ARCHITECTURAL REVIEW BOARD STAFF REPORT

Project #/Name	ARB-2021-96: Umansky Subaru Building Renovation
Review Type	Final Review of a Site Plan and Architecture
Parcel Identification	04500-00-00-068D4
Location	On the west side of Routh 29 North, at the intersection of Hilton Heights Road and Route 29.
Zoned	Highway Commercial (HC), Entrance Corridor (EC)
Owner/Applicant	Umansky Properties TOC LLC/Design Develop LLC (Kevin Schafer)
Magisterial District	Rio
Proposal	The applicant proposes to renovate the Umansky Subaru showroom building by applying ACM (aluminum composite material) panels on portions of the Rt. 29 elevation and the majority of the Hilton Heights Road elevation, by painting the existing EIFS gray, and by adding elements to the south and east elevations including towers and canopy. The renovation proposal also includes leaving a portion of the existing brick unpainted and additions to the rear (west) elevation.
Context	The Umansky Subaru site is located in the heavily developed Rt. 29 commercial corridor. The Subaru building is located just south of the Umansky Auto Park (previously Brown) building. A Walmart is located directly to the south across Hilton Heights Rd. J

Figure 1: SDP2003-67 Approved Landscape Plan (Phase I)

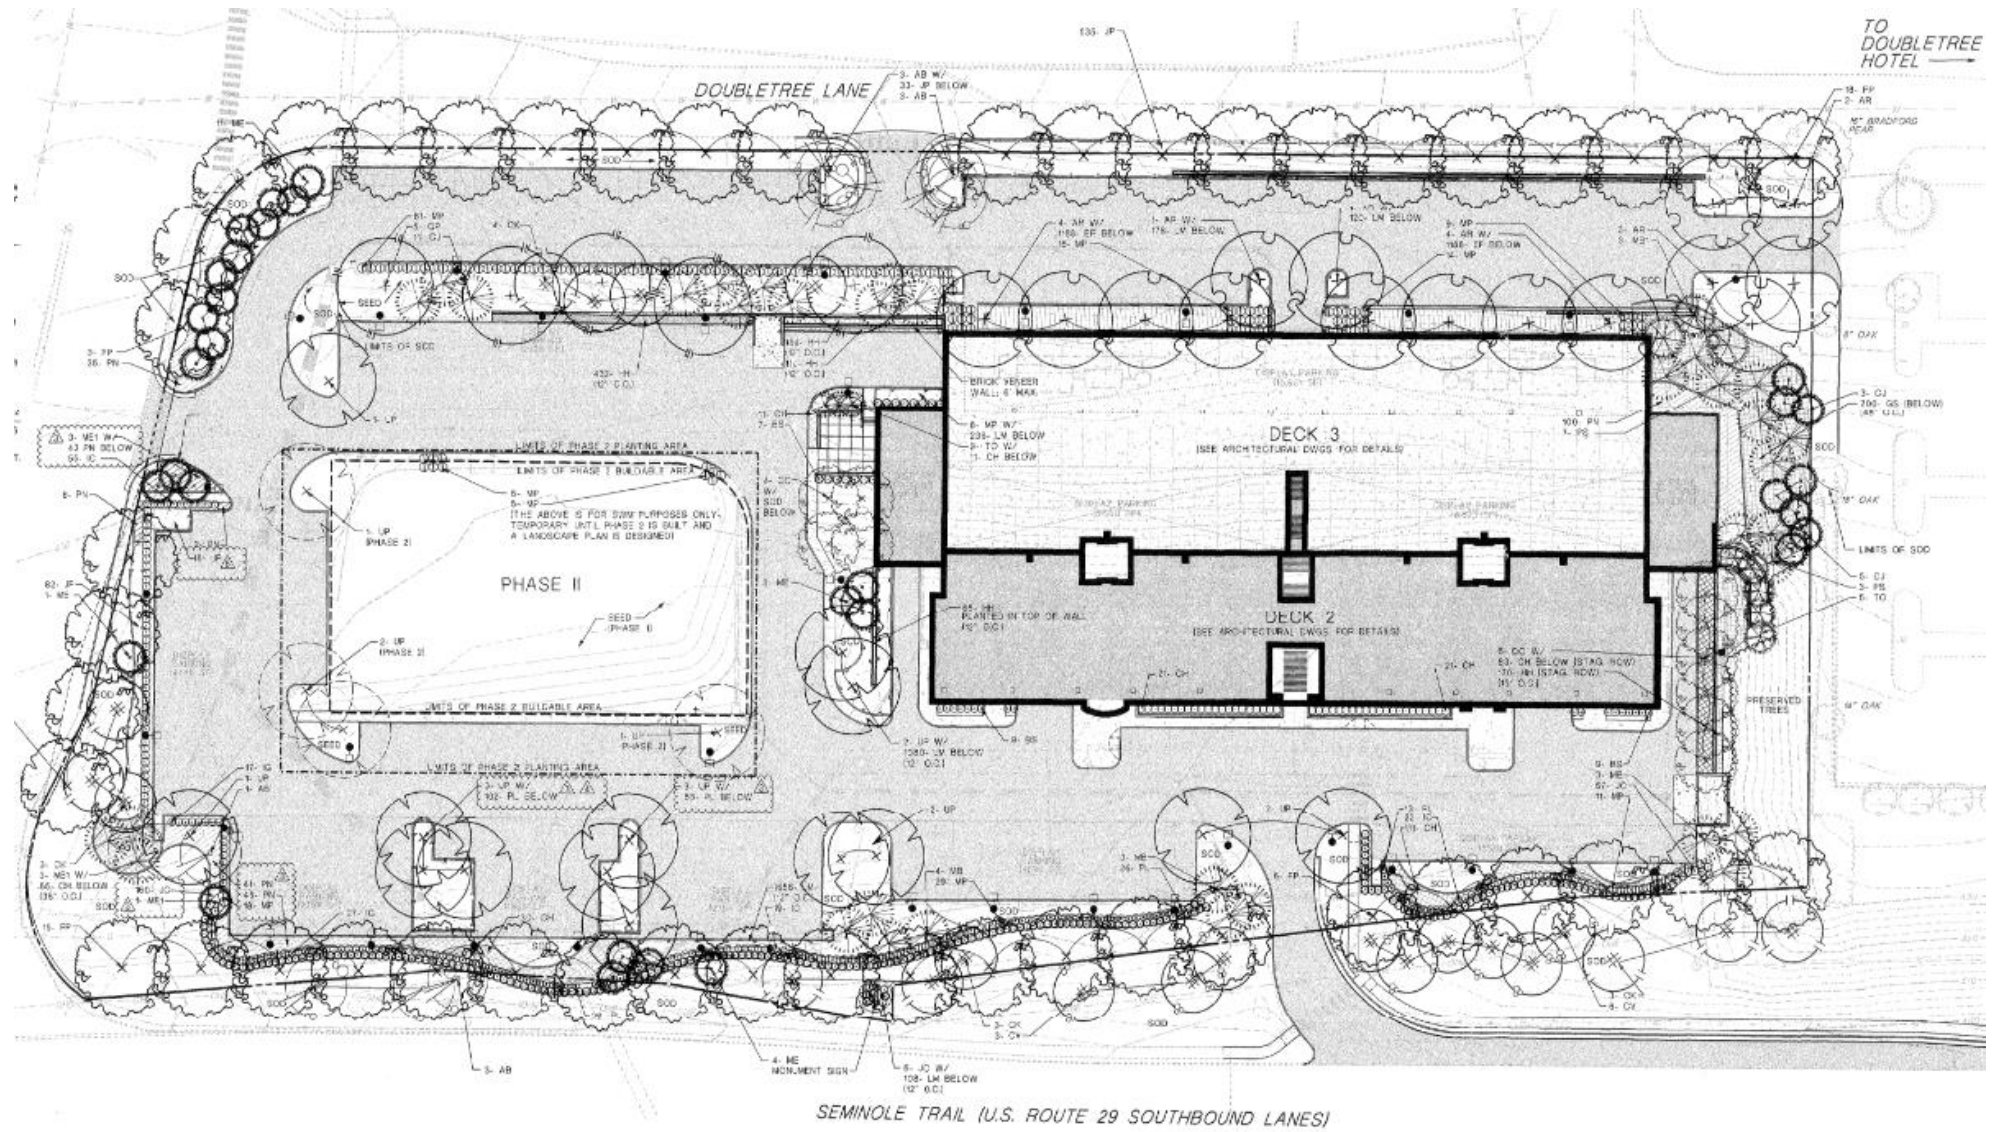
Landscaping	Revise the landscape plan to show all previously approved landscaping, and further clarify the proposal to identify plants to remain, plants to be removed, and plants to be added.	The landscape plan proposes a few changes to existing landscaping, and shows some, but not all, of the previously approved landscaping.	See landscaping recommendations below.
7	The requirements of the Guidelines regarding landscaping are intended to reflect the landscaping characteristic of many of the area's significant historic sites which is characterized by large shade trees and lawns. Landscaping should promote visual order within the Entrance Corridor and help to integrate buildings into the existing environment of the corridor.	None.	Established frontage trees exist on both Rt. 29 and Hilton Heights Rd. The trees are to remain, and they meet quantity requirements. The landscape plan shows existing landscaping, but not all the previously approved landscaping is in place (Fig. 1). Shrubs along the perimeter of the parking lots fronting Rt.	Revise the landscape plan to provide the previously approved row of shrubs along the parking area adjacent to Rt. 29, and along the parking area adjacent to Hilton Heights

3. Revise the landscape plan to provide the previously approved row of shrubs along the parking area adjacent to Rt. 29, and along the parking area adjacent to Hilton Heights Road.
